Technical Service Bulletin

SUBJECT:		No: TSB-16-11-001	
ROCKER COVER OIL LEAK		DATE: August, 2016	
		MODEL: 2014-16 Outlander	
CIRCULATE TO:	<input type="checkbox"/> GENERAL MANAGER	<input checked="" type="checkbox"/> PARTS MANAGER	<input checked="" type="checkbox"/> TECHNICIAN
<input checked="" type="checkbox"/> SERVICE ADVISOR	<input checked="" type="checkbox"/> SERVICE MANAGER	<input checked="" type="checkbox"/> WARRANTY PROCESSOR	<input type="checkbox"/> SALES MANAGER

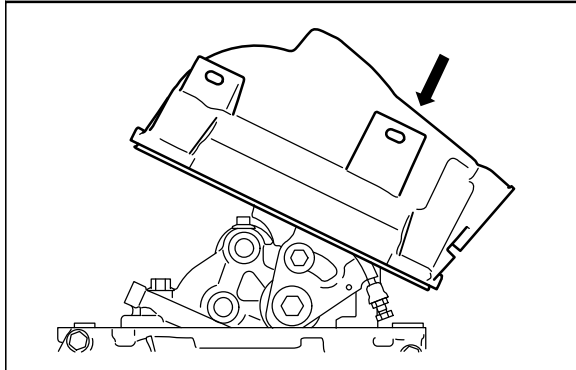
b. Apply liquid gasket at rear of engine as shown in the illustration below.

- Apply a 4 mm thick bead at the base of the arch.
- Apply a 4 mm diameter bead along the arch, about 3 mm from the edge, to a height of 20 mm above the cylinder head (View D).
- Apply a 10 mm diameter bead at the bottom of the arch as shown (View A).

a. Apply the liquid gasket in a uniform bead with a thickness of 4 mm (0.2 inch) diameter.

NOTE: Do not use an excess amount so that the liquid gasket does not ooze out after the rocker cover is reinstalled.

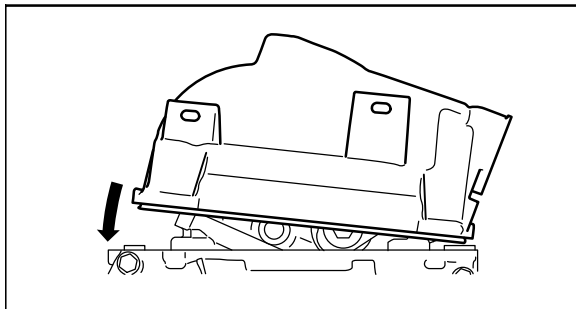
⚠ CAUTION Install along the spark plug guide while being careful not to damage the spark plug guide oil seal.

a. Raise the exhaust side of the rocker cover, and insert it at an angle along the spark plug guide.

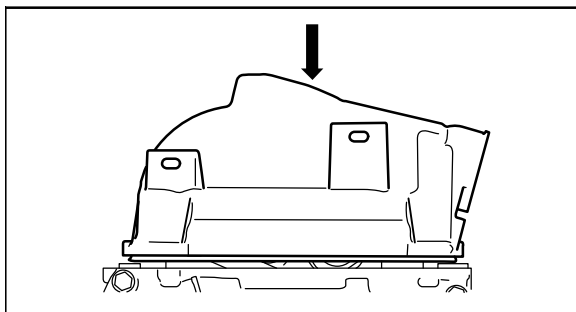
⚠ CAUTION Ensure that the rocker cover is properly seated. If the rocker cover is seated on the cylinder head at a slight diagonal along the spark plug guide, the sealant, which is applied at the joint between the cylinder head and the timing chain case, will be misaligned. This may cause oil leakage.

b. Hold the rocker cover horizontally right before seating it on the cylinder head.

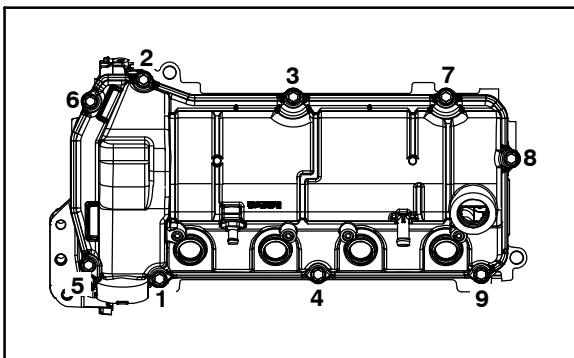
c. Lower the rocker cover vertically to seat it on the cylinder head.

NOTE: Do NOT slide the cover horizontally into position.
